TO: Lashta Haidari, Steven Findlay
FROM: Ody Murlianto, Richard West, Ryan Miller
SUBJECT: Meriton Dee Why Review of Traffic Matters
OUR REF: 2196969A-ITP-MEM-RPT RevA.docx
DATE: 28 March 2017

Northern Beaches Council has engaged WSP | Parsons Brinckerhoff to undertake a review of the Traffic Impact Assessment undertaken to support the Development Application submission for the subject development.

TX.15

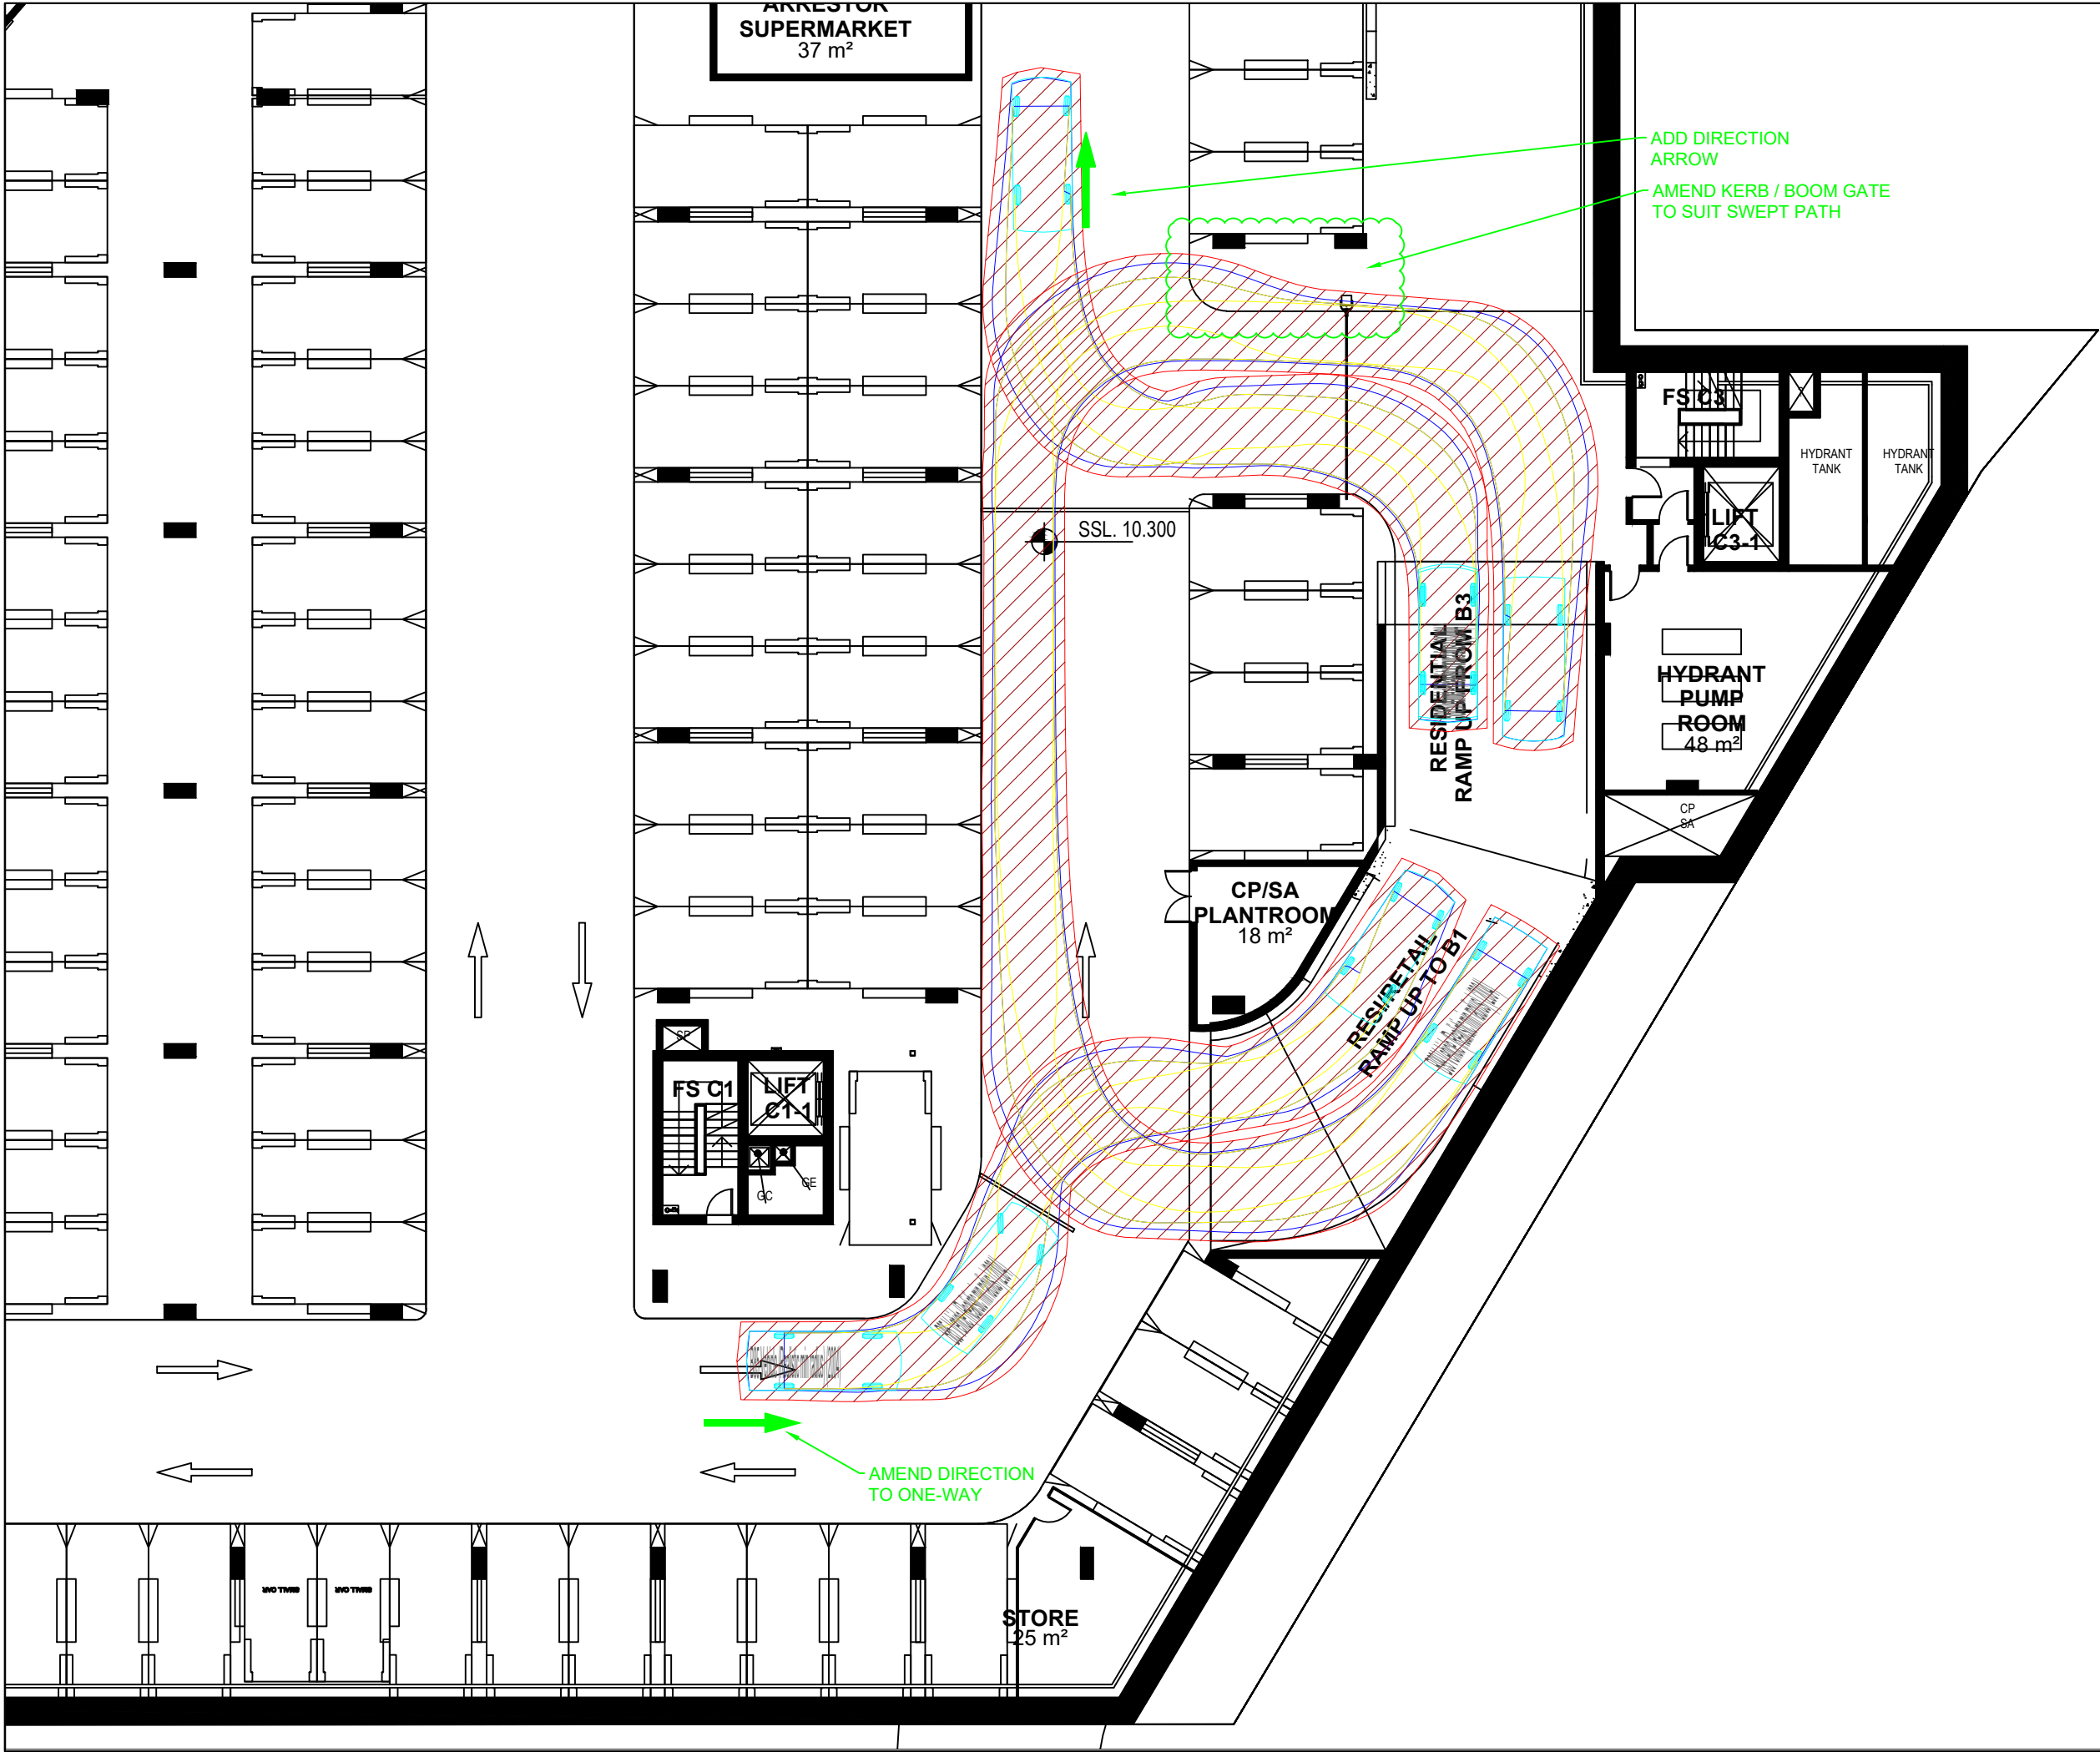
CUT-BACK KERB TO
SUIT SWEEP PATH

THIS PARTICULAR WALL SHOULD BE
SEE-THROUGH TOWARDS THE BOTTOM
OF THE RAMP SO THAT A CAR STOPPED
BEHIND THE PROPOSED STOP LINE
CAN OBSERVE VEHICLES TRAVELLING DOWN
THE RAMP.

drawing title
Loading Bay Vertical Clearance
MRV 3.6m Height Entry and Exit

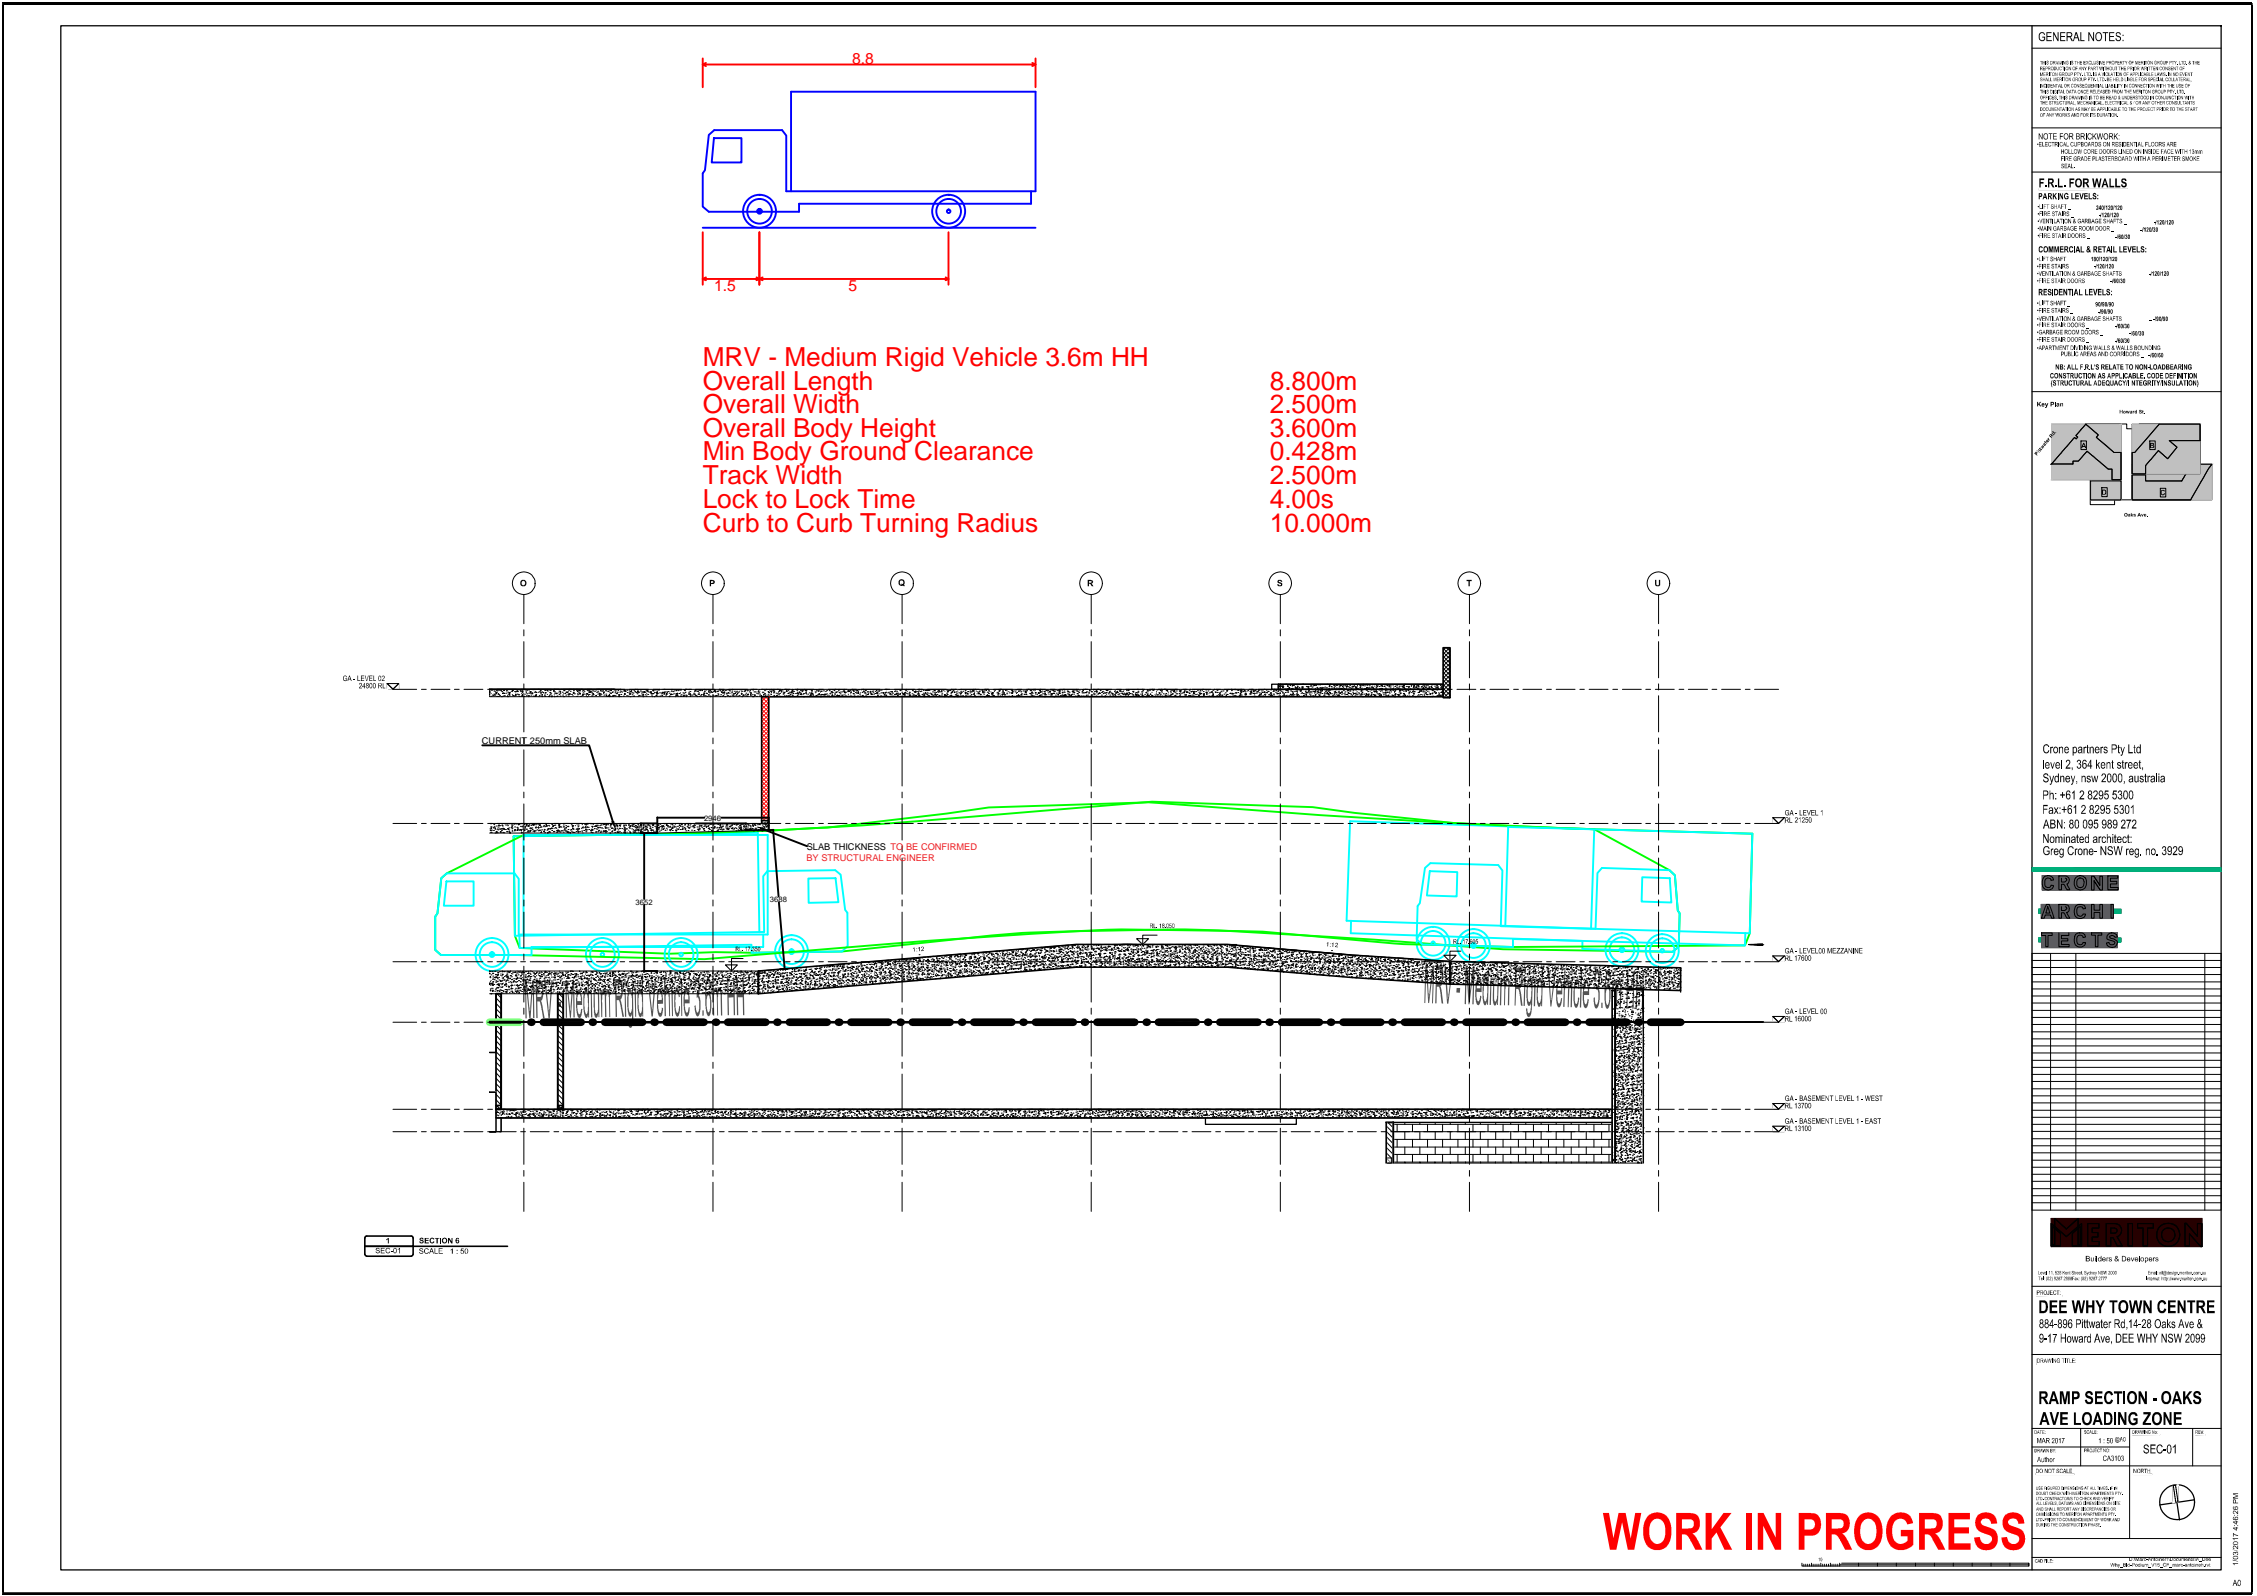
An issue was raised with regards to the non-compliance of the overhead clearance proposed at the loading dock at Oaks Avenue. The largest design vehicle of a Medium Rigid Vehicle (MRV) was selected in a number of turning path assessments submitted for review including the drawings prepared on 17 February 2017. The minimum overhead clearance required for a Medium Rigid Vehicle is 4.5 metres as per Table 2.1 of AS 2890.2:2002.

The overhead clearance proposed for the development was measured at 3.286 metres. This was later reviewed to show 3.615 metres in the drawing (Ref: Sec-01) prepared by the Applicant in March 2017.

The Oaks Avenue loading dock has been provided with a head height clearance of 3.6m. The ramp grades and geometry is fully compliant (sic) with AS2890.2 (2002). Vertical clearance tests have also been undertaken using an MRV (with a reduced head height of 3.6m) and show satisfactory operation of the loading dock entry ramp with no head height or bottom scraping. The vertical clearance tests are presented in Appendix B.

Architectural design has been proposed to suit the 3.6 metres overhead clearance and is shown in drawing number TX.01 prepared on 21 March 2017. A copy of the drawing is attached in Appendix E.

The response provided by the applicant in the report prepared on 22 March 2017 is considered in-line with the discussion held on 17 March 2017 to address the issues associated with the overhead clearance for the loading dock at Oaks Avenue to ensure its functionality.
